ASI-10

Date: July 5, 2022

Project: DeLDOT Georgetown Administration Building

07/05/22
DATE SHEET NO.
20069 ASK-07
PROJECT NO.

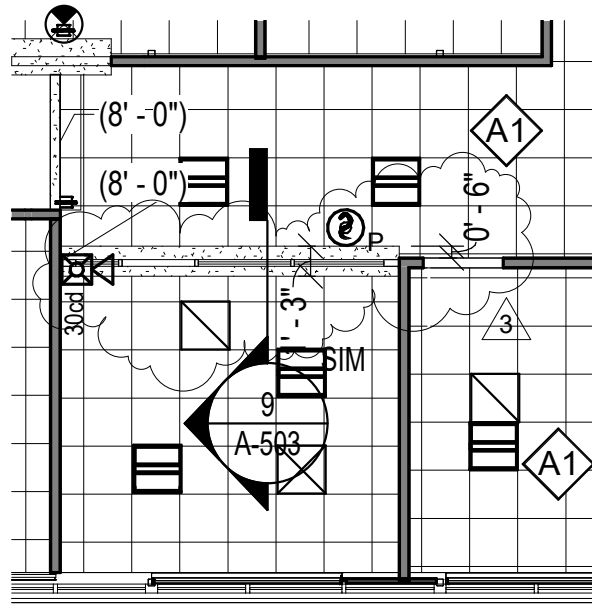
1. Add gypsum board soffit above new furniture system wall. See sketch ASK-07.
2. Add additional hardware set #10 for new door in furniture wall. See sketch ASK-07.
